Diversified Metal Fabricators Service Bulletin SB 2051

Title	RW-1019 Long Arm Slots Issues for 2005-2008 Ford F-450/550's
Document No.	SB 2051
Issue Date	8/13/07 (WAK)
Units Affected	2005-2008 Ford F-450s and F-550s
Purpose	This service bulletin addresses a product improvement for RW-1019 front railgear on model year 2005 and newer Ford F-450's and F-550's.

Fig. 1: New Longarms

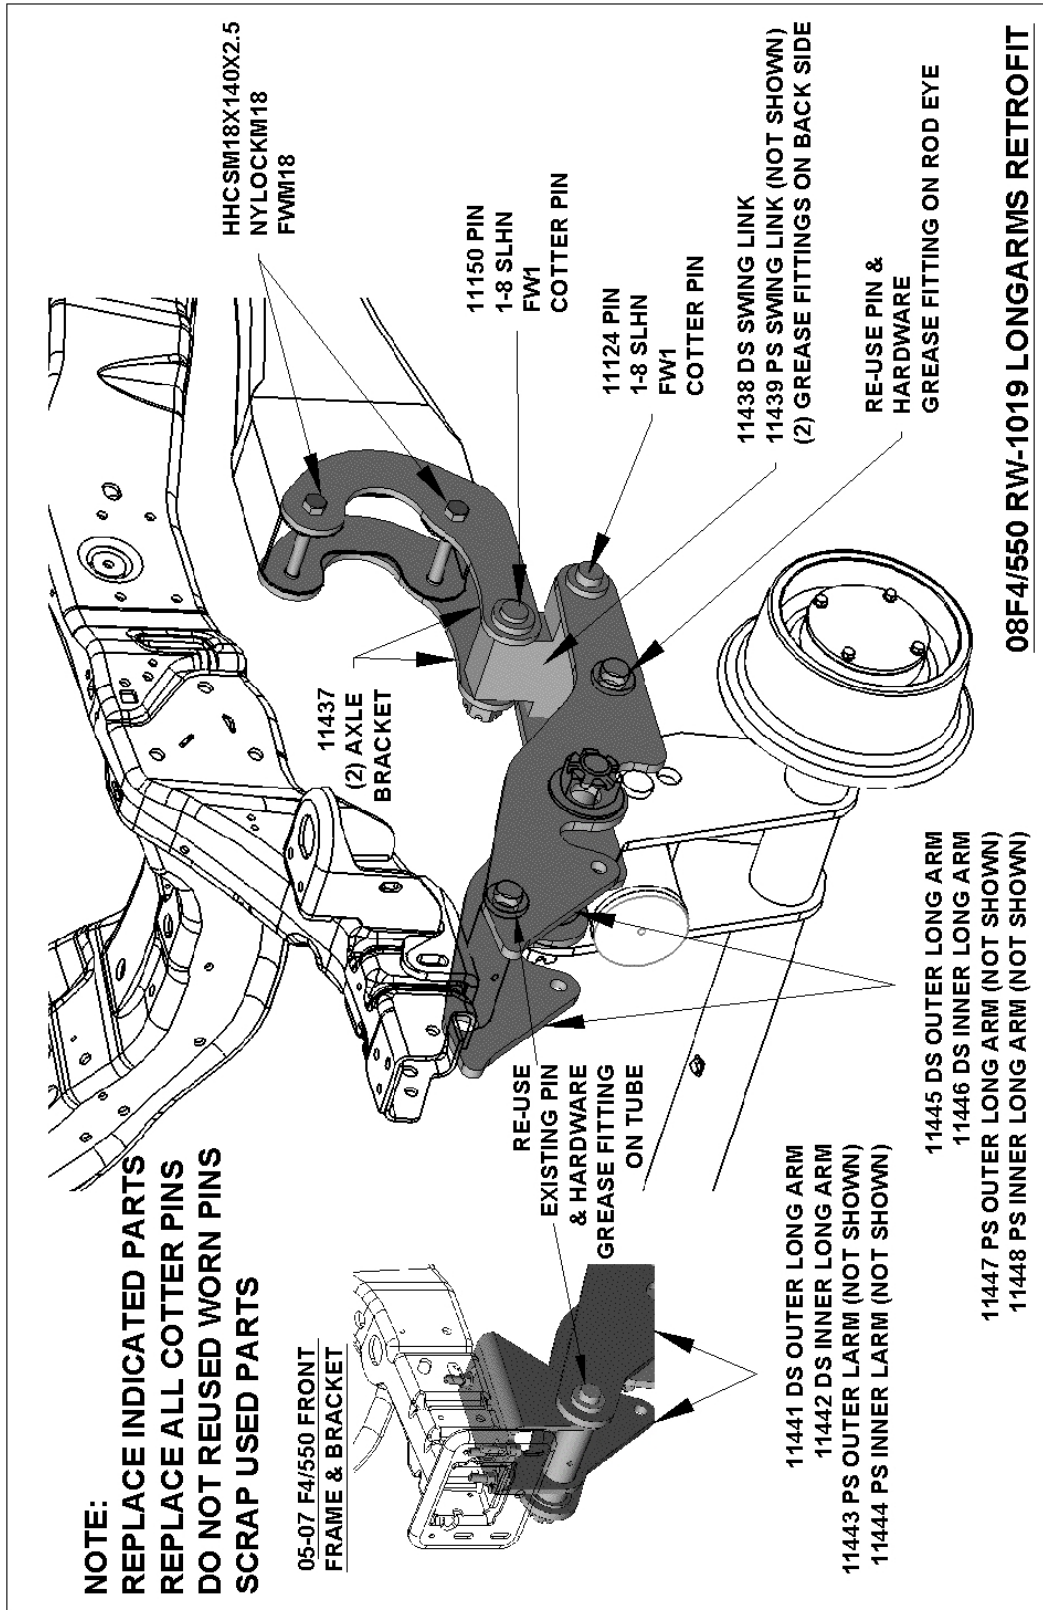
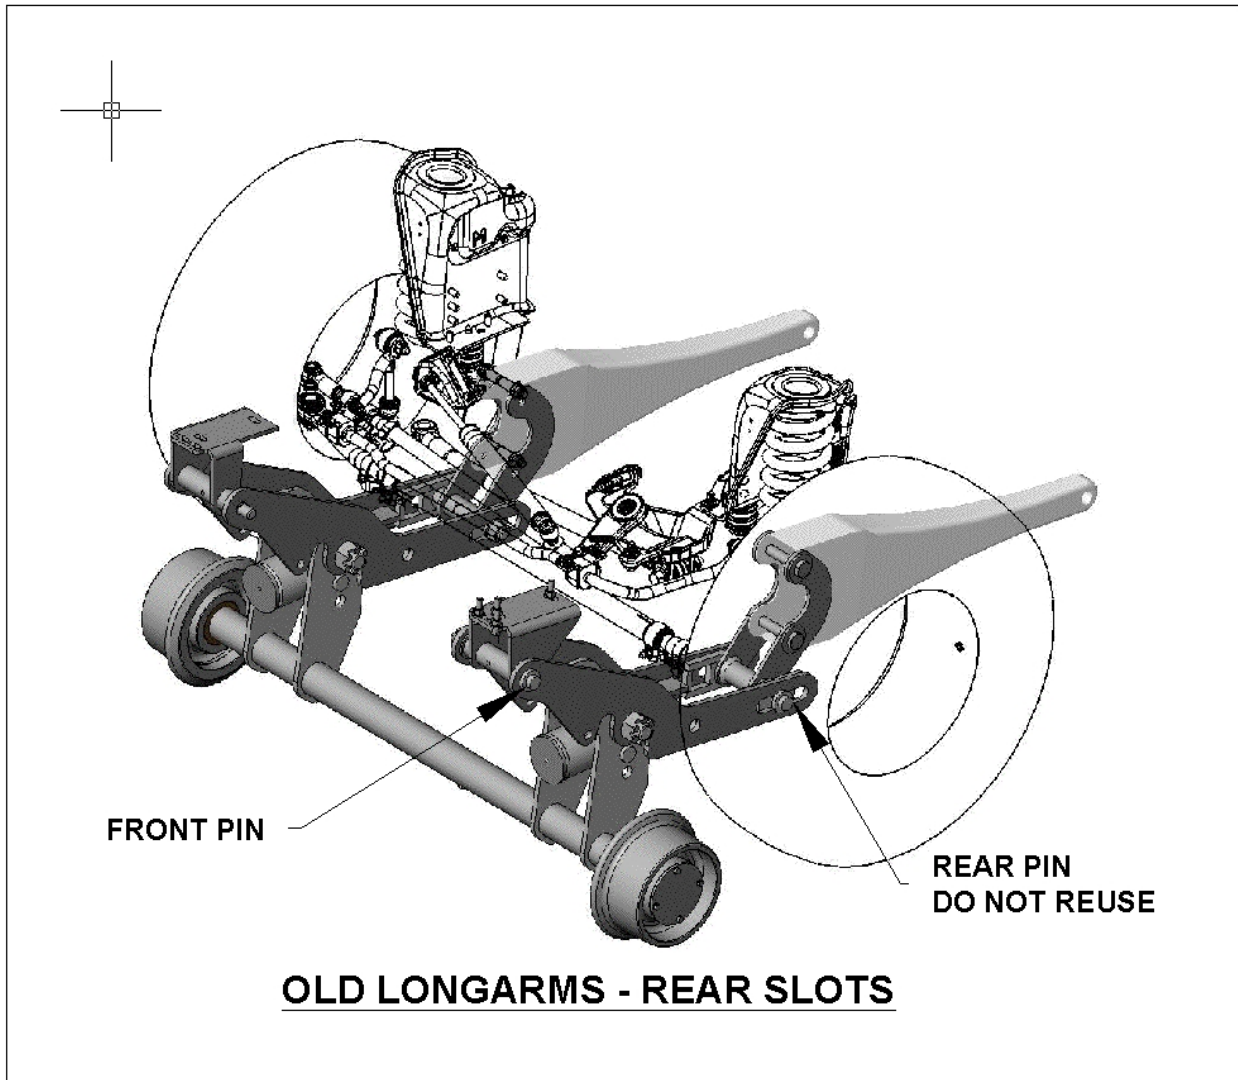
In order to improve resistance to wear on pins, RW-1019 railgear for '05-'08 Ford F4/550 has been re-designed. Units with any configuration of slots (front, rear, with or without slidebars) should be converted to the current configuration. The current configuration uses a swinging link to replace the pin/slot.

- Longarms with front slots
- Longarms with rear slots with or without guide rails & slide bars (see Fig. 1)

These arms will be replaced with new longarms and will be provided with new rear pins, washers and nuts. The axle brackets rear pins will also be replaced.

The only difference between the 05-07 kits and the 08 kits are the front end of the long arm and the front bracket due to differences in the the frame ends. The front bracket are re-used as is.
